# Mallee Wind Farm

Submissions Report

March 2026

Prepared by  
Umwelt (Australia) Pty Limited

**Figure 4.1 Archaeological Sensitivity of the Project Area**

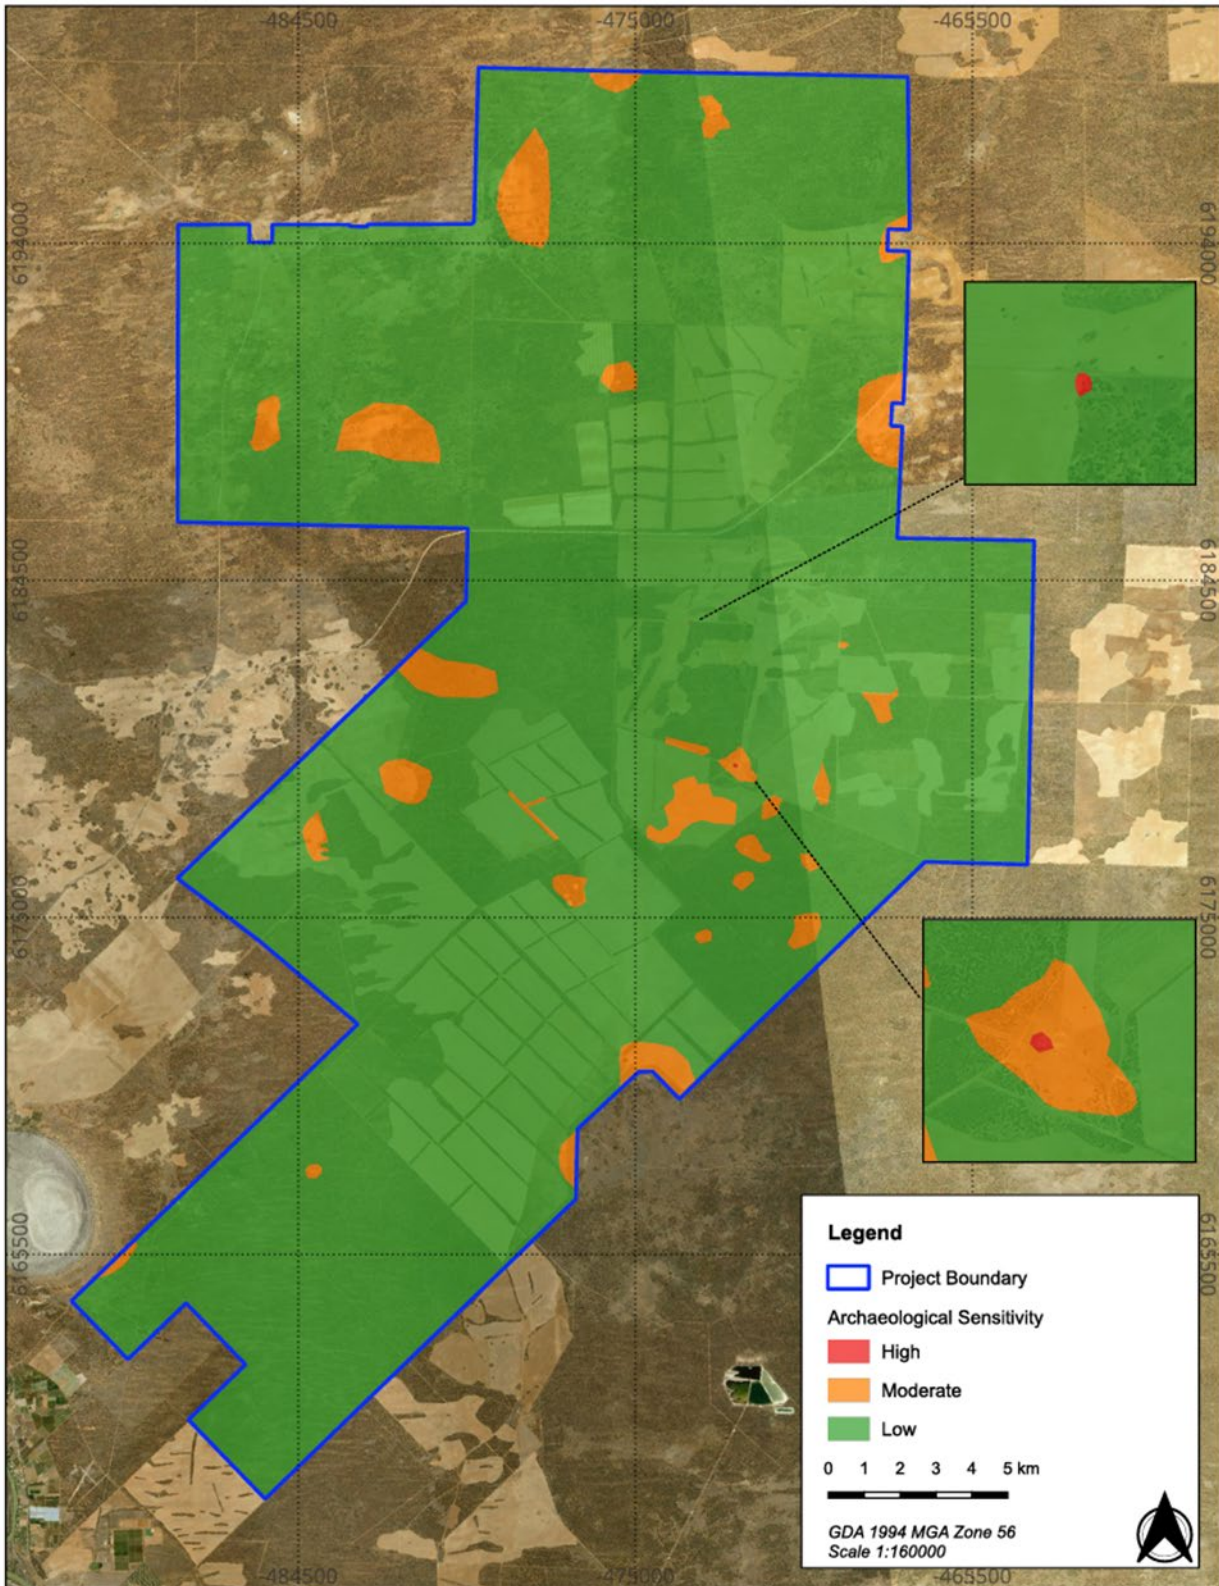
As standard practice, Heritage NSW requires the identification of Potential Archaeological Deposits (PADs) and subsurface testing of those deposits to establish their archaeological significance. Please provide clarification and detail of the assessment for PADs within the project area, for the survey units, the newly identified sites and the landforms surrounding the newly identified sites. Justification as to why test excavations should not occur prior to construction in the project area should also be provided. If adequate justification is not provided, Heritage NSW recommends that test excavations occur prior to any construction impacts in the project area.

Chapter 8: Analysis and Discussion as well as relevant sections in Chapter 3: Landscape Context, Chapter 4: Archaeological Context and Chapter 5: Predictive Model of the ACHA have been updated in to provide further justification that no test excavation is required for the Project.

**Figure 4.1** depicts the archaeological potential of the Project Area, which was developed using topographic maps, modern and historical aeriels, predictive modelling, and survey results. **Figure 4.1** represents both surface and subsurface archaeological potential, with the only location for subsurface archaeology being present in a single area of high archaeological potential associated with (Mallee Windfarm PAD / 46-3-0236), which will not be impacted by the Project.

**FIGURE 4.3**  
**Predicted Wind Turbine**  
**Noise Level Contours –**  
**Mallee Cliffs National Park**

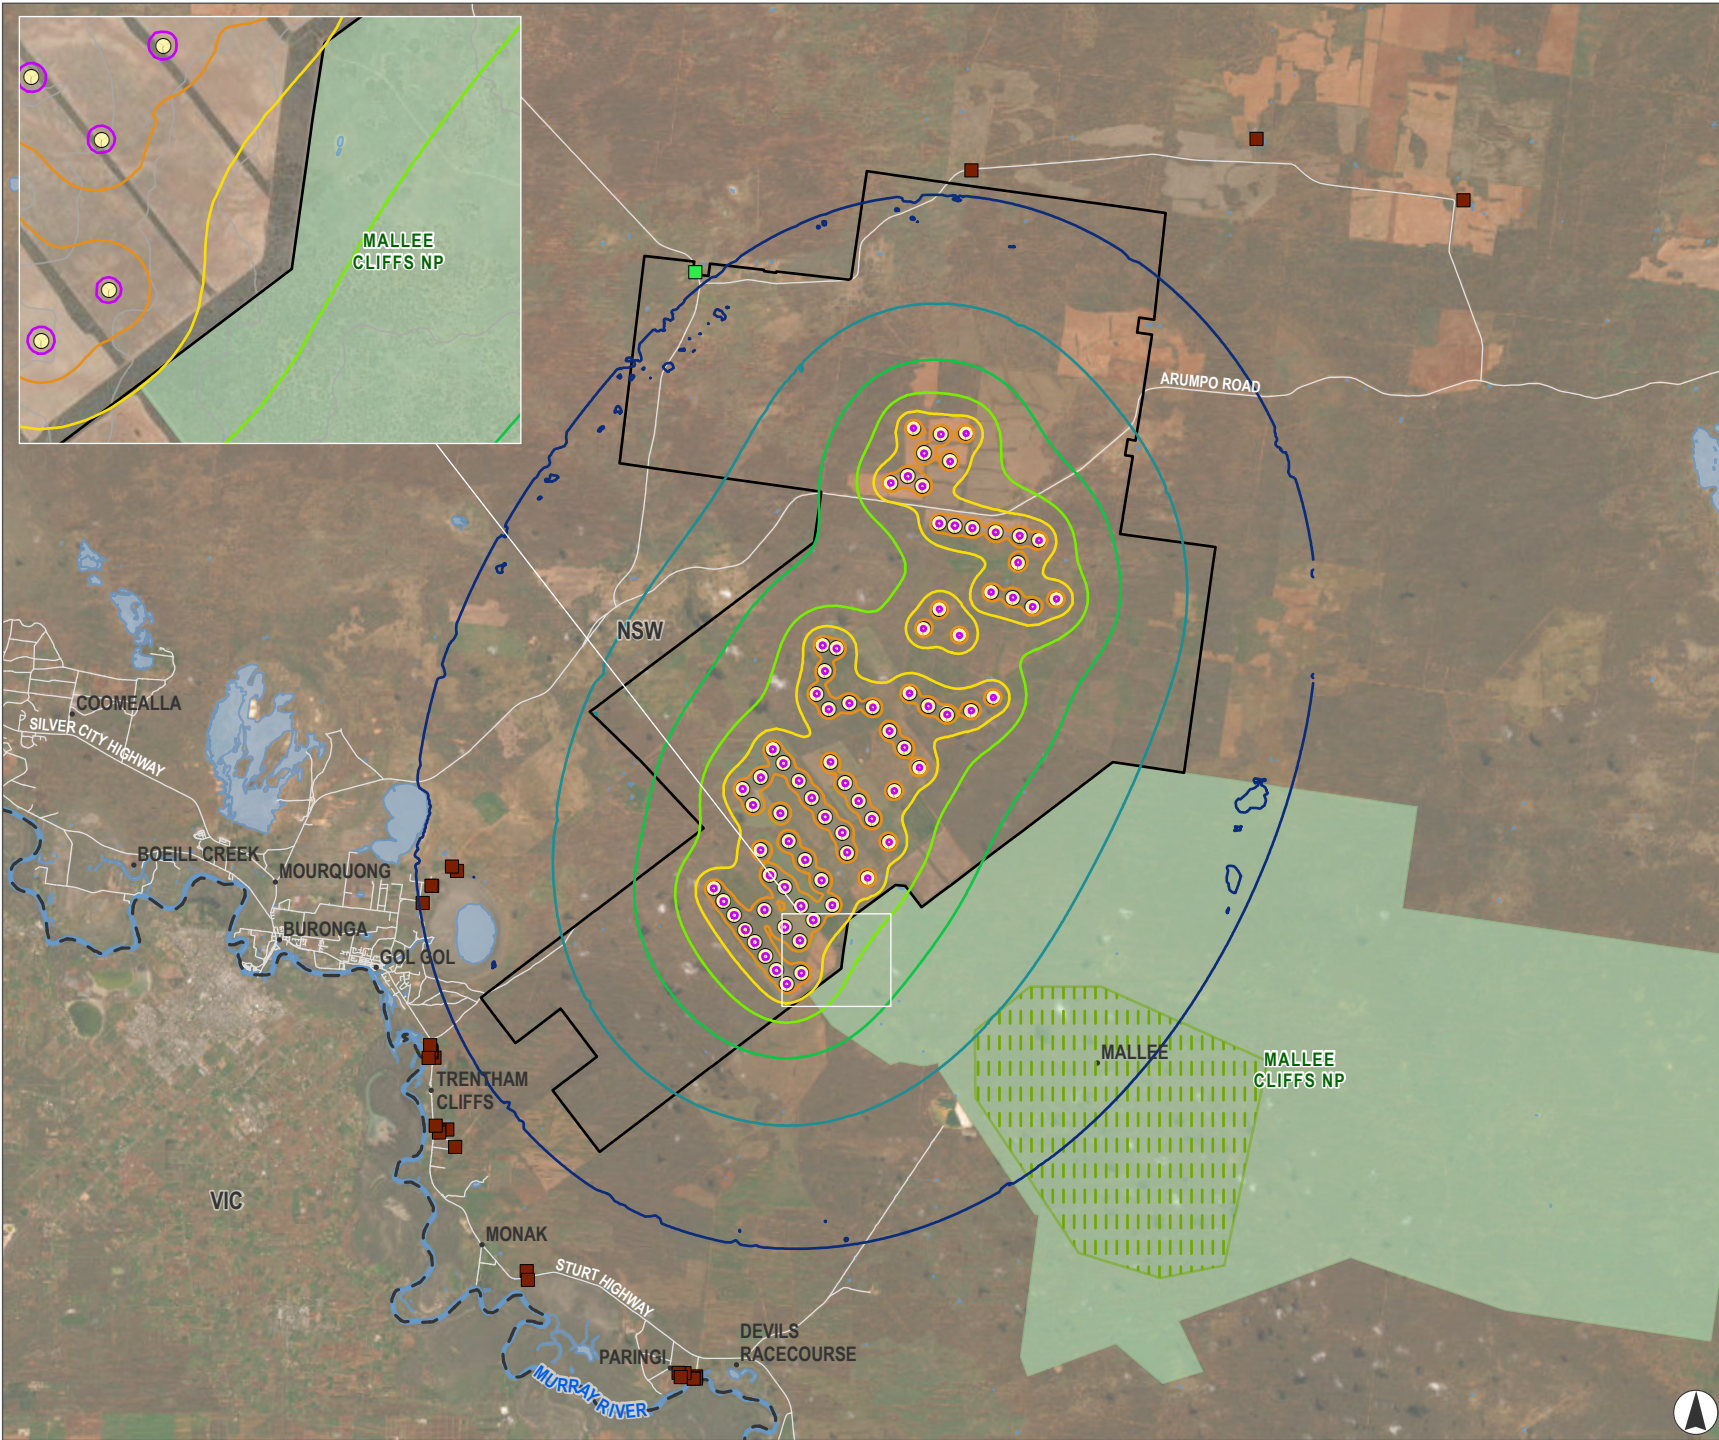
*The NVIA indicates that the maximum operational noise of the project on the Mallee Cliffs National Park boundary is 40dB (Figure 5, NVIA). NPWS is concerned that noise levels above 40dB(A) have the potential to impact on wildlife occupying Mallee Cliffs National Park.*

**Figure 4.3** below shows highest predicted WTG noise level contours within Mallee Cliffs National Park, as presented in the Noise and Vibration Impact Assessment (Appendix 10 of the EIS).

As shown in **Figure 4.3**, predicted WTG noise levels are in the order of 40 dB at the Mallee Cliffs National Park boundary, reducing to approximately 25 dB at the boundary of the Asset of Intergenerational Significance (AIS) area and further reducing to levels of 20 dB or less within the majority of the National Park.

Figure 4.4 Road Network Map Referenced by WaterNSW

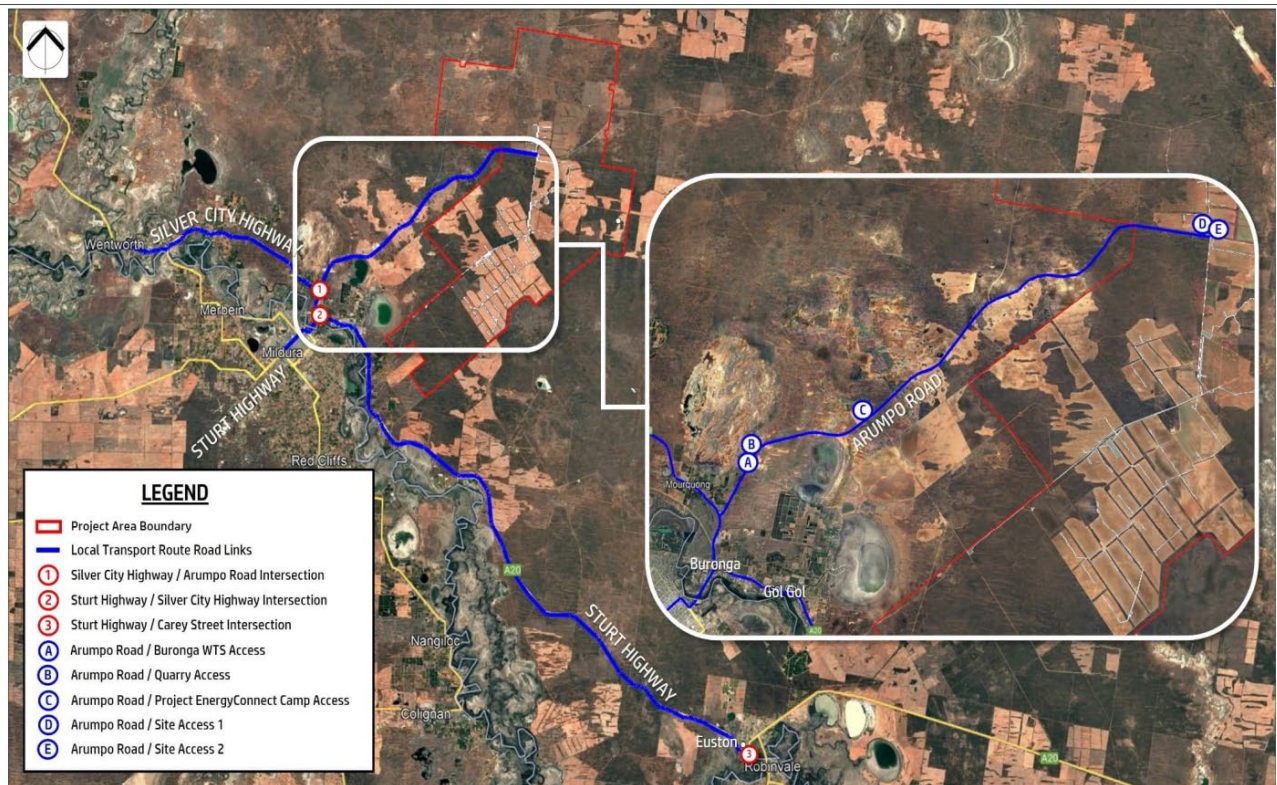
*There are at least three active groundwater monitoring sites that may potentially be impacted by works associated with the development proposal, with locations B and C taken from Figure 3 of Appendix 12 to the EIS...*

WaterNSW advised that there are two (2) monitoring sites (GW087083 and GW088479) located near the existing Quarry Access and another site (GW087531) located near the Project EnergyConnect Camp Access, which are identified as access points “B” and “C” in Figure 3 of the Traffic Impact Assessment (Appendix 12 of the EIS), reproduced in **Figure 4.4** below.

It is noted that the figure referenced by WaterNSW provides context for the local road network only and does not denote where Project-related road works are proposed to occur. Neither the existing Arumpo Bentonite Quarry on Arumpo Road (Access B) or the Project EnergyConnect Camp (Access C) form part of the proposed Project.

Spark Renewables may source material for the Project from the quarry during construction (refer to **Section 4.2.13.2**), however, this would occur pursuant to the quarry’s existing approvals and no road upgrades are proposed at this location as part of the Project. Additionally, no usage of the Project EnergyConnect Camp is proposed, and this access point is shown for information only. Consequently, no impacts to these WaterNSW monitoring sites are anticipated due to the carrying out the Project.

### Figure 5.5 Photomontage from Gol Gol Swamp (PM05)

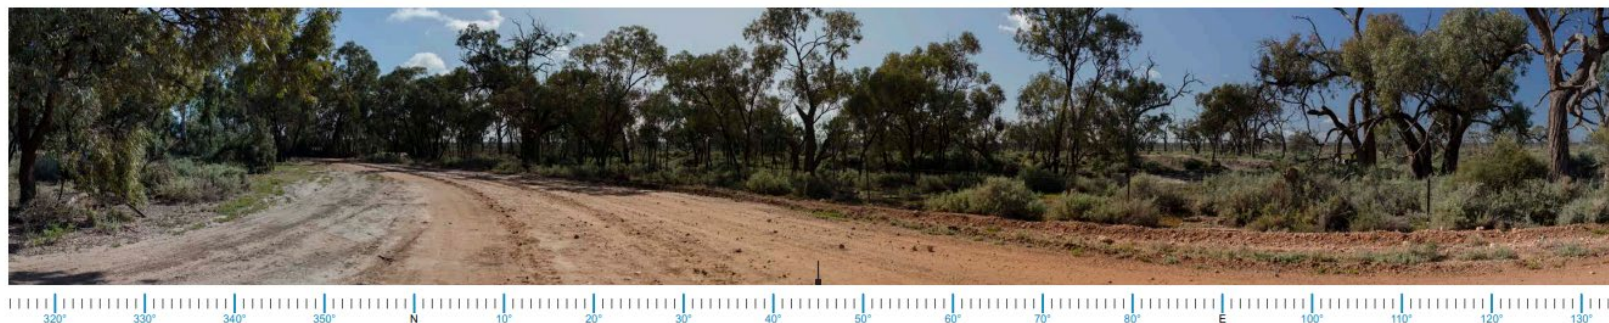
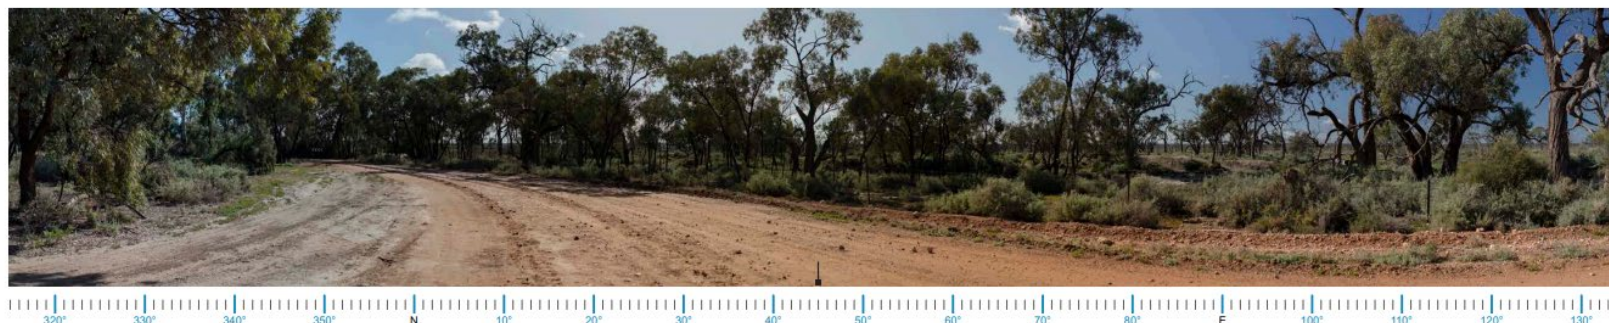
*The Mallee Wind Farm will have a dominant visual impact on the Mallee Cliffs National Park, Buronga Gol Gol and surrounding landholders. It will also have a dominate view from the lunette around the Gol Gol Swamp. – CS57 Grand Junction  
Pty Ltd*

The LVIA concludes that visual impacts within the Mallee Cliffs National Park will be limited, due in part, to the restricted public access within the National Park. The Mallee Cliffs National Park forms part of LCU 05 ‘National Parks and Conservation Areas’ identified in the LVIA. The LVIA indicates that visual impacts to LCU 05 will be low, and that overall, the Project is unlikely to degrade the scenic values of the Mallee Cliffs National Park.

Gol Gol Swamp forms part of LCU 02 ‘Creek and River Systems’ and is represented as Viewpoint VP11 as identified in the LVIA. The visual impact rating at VP11 is assessed as low. A photomontage from this location (PM05) is reproduced in **Figure 5.5**. The visual impact rating to LCU02 was assessed as low, noting that existing riparian vegetation and minor topographical undulations may fragment views from areas within the LCU. Due to the distance and intervening dense vegetation typical of the LCU, the Project will form a minor element in the overall visual landscape, and the scenic integrity is likely to remain intact. **Figure 5.4**, shadow flicker impacts associated with the Project, are largely confined to the Project Area, with no impacts to neighbouring private properties predicted.
